To: T10 Technical Committee
From: Rob Elliott, HP (elliott@hp.com)
Date: 18 October 2004
Subject: 04-340r0 SAS-1.1 OPEN_REJECT BAD DESTINATION handling

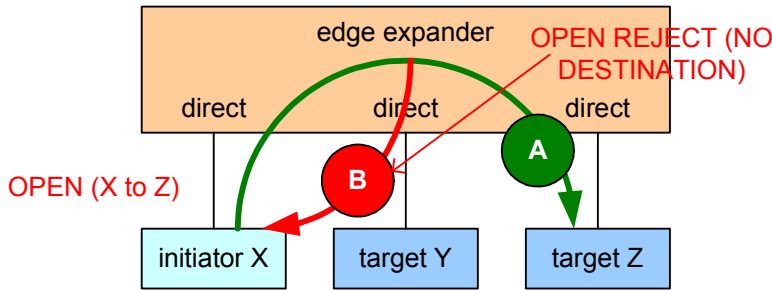
When the physical link to a destination SAS address goes down, the response can be either OPEN_REJECT (NO DESTINATION) or OPEN_REJECT (BAD DESTINATION) depending on whether there is a subtractive port in one of the expanders (see figure).

- a) Require that expanders return NO DESTINATION instead of BAD DESTINATION for phys using either the subtractive or table routing methods (not just subtractive as currently defined). Phys using the direct method (i.e. attached to an end device) would still return BAD DESTINATION. This means the request must have arrived through a subtractive phy in an attached expander; or
- b) Treat BAD DESTINATION as a retry-class response rather than an abandon-class response.

The latter is suggested.

With no subtractive port:

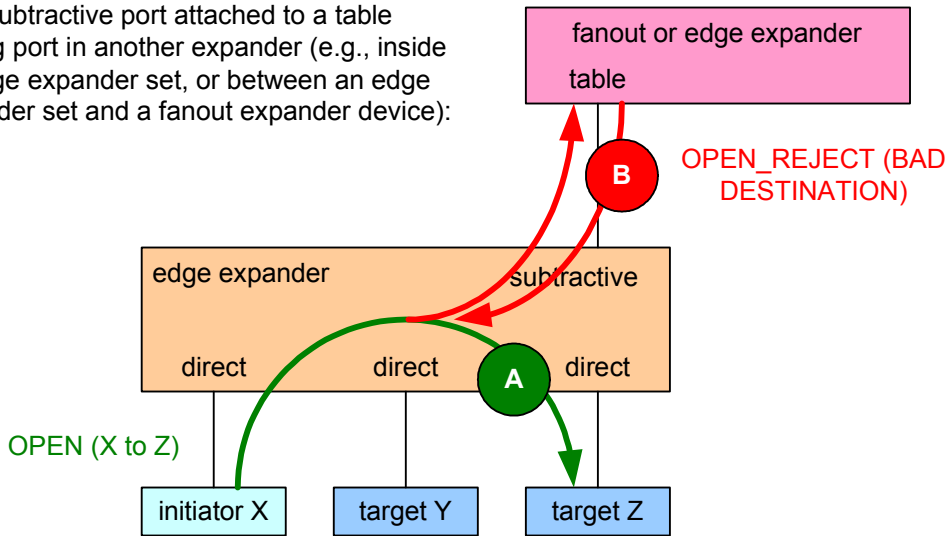
- A) before target physical link goes offline, OPEN routed to target
- B) after target physical link goes offline. OPEN_REJECT (NO DESTINATION) from edge expander

With subtractive port attached to a table routing port in another expander (e.g., inside an edge expander set, or between an edge expander set and a fanout expander device):

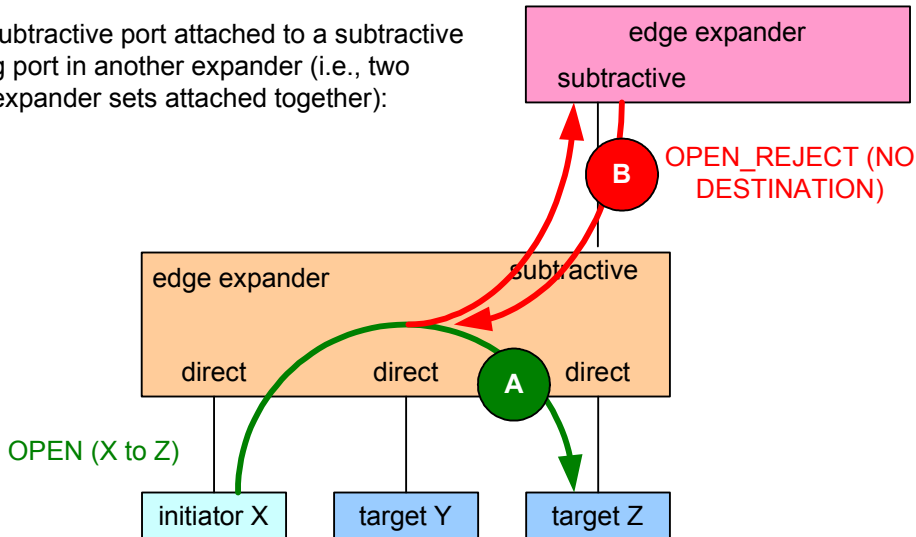
OPEN_REJECT (NO DESTINATION) is in the retry class of responses, meaning the OPEN will be attempted again until the I_T nexus loss timer expires. OPEN_REJECT (BAD DESTINATION) is in the abandon class, meaning the OPEN is not reattempted.

- A) before target physical link goes offline, OPENS routed to target
- B) after target physical link goes offline, OPEN_REJECT (BAD DESTINATION) from top expander

If a target receives BAD DESTINATION, it will continue retrying until its I_T nexus loss timer expires.
